DOCKET NO. STN 50-501
ADDITIONAL INFORMATION - PSAR
HAVEN NUCLEAR PLANT

WISCONSIN UTILITIES PROJECT
HAVEN NUCLEAR PLANT
APPLICANTS' RESPONSE

U. S. NUCLEAR REGULATORY COMMISSION
REQUEST FOR ADDITIONAL INFORMATION

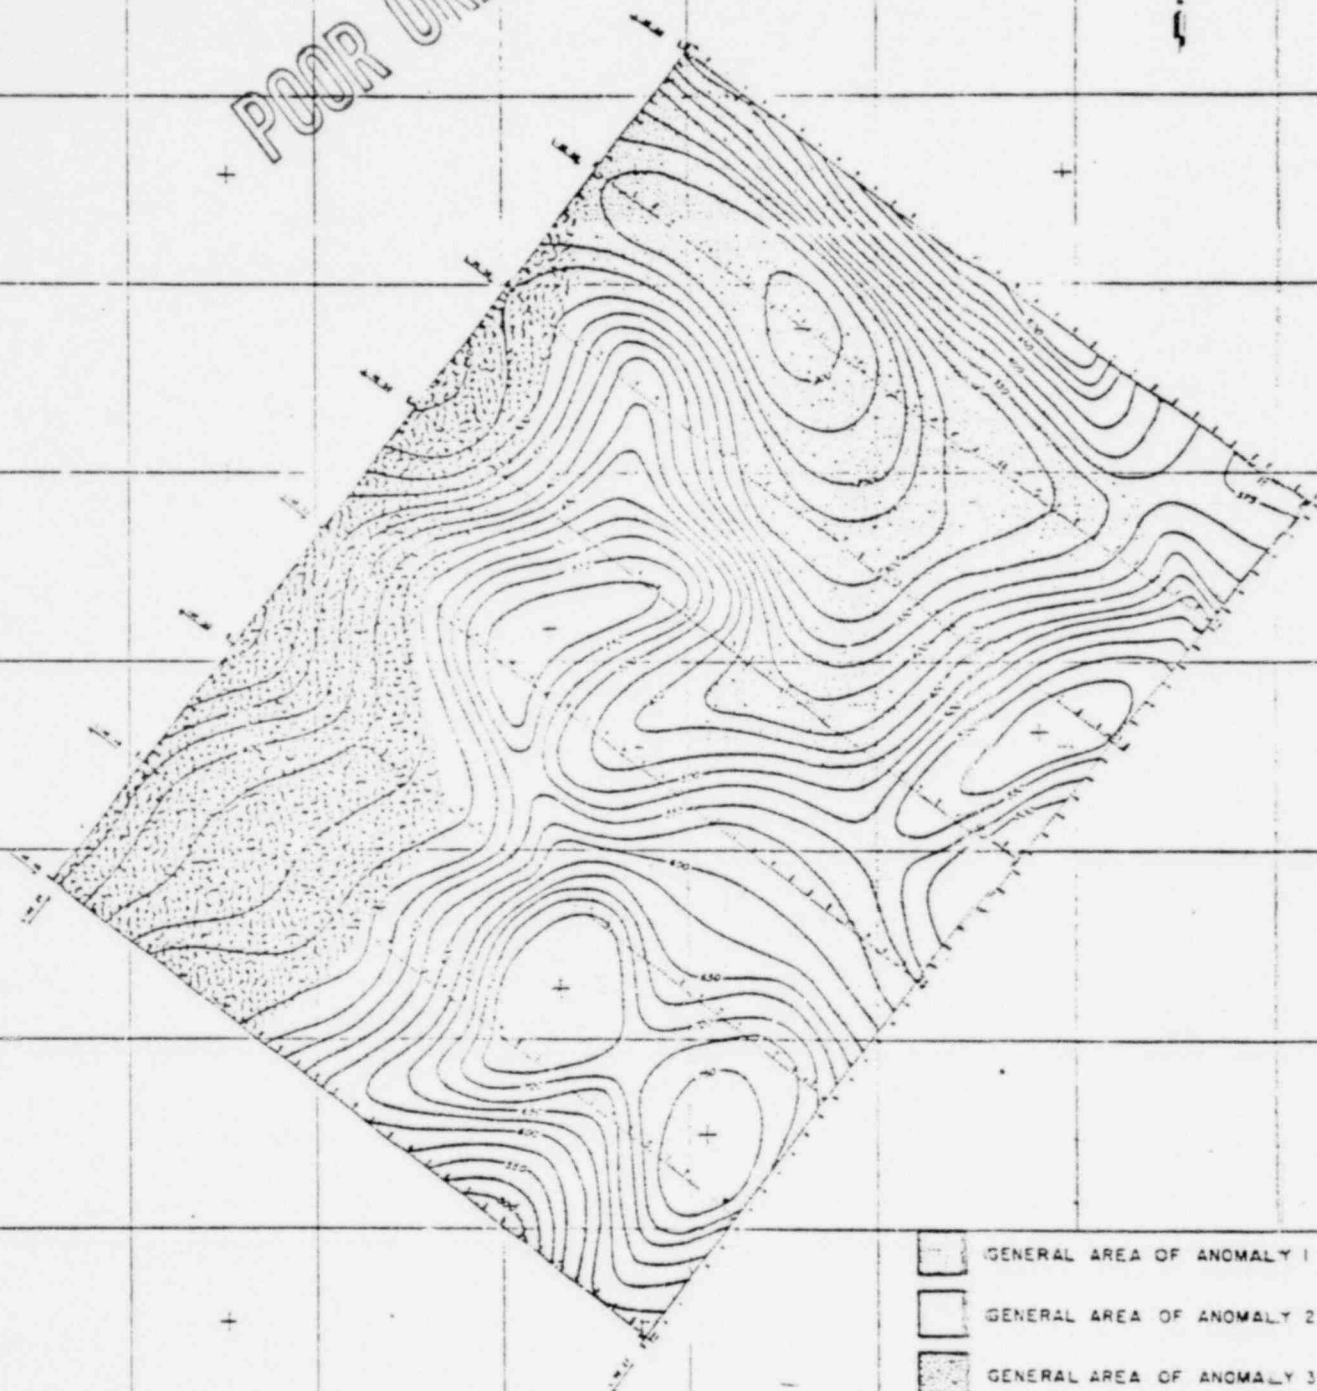
Pages 21 thru 24 of PSAR Appendix 2Q discuss four magnetic anomalies, numbered 1, 2, 3 and 4. The PSAR references Appendix 2Q, Figure 8 for the anomalies location in the Fairfield Study Area II. The location and areal extent of anomalies 1, 2, 3 and 4 is unclear as shown on Figure 8, Appendix 2Q. Please modify Figure 8 to clarify the location and areal extent of these anomalies.

Figure 8, attached, has been reproduced to show the location and extent of the four magnetic anomalies discussed in Appendix 2Q.
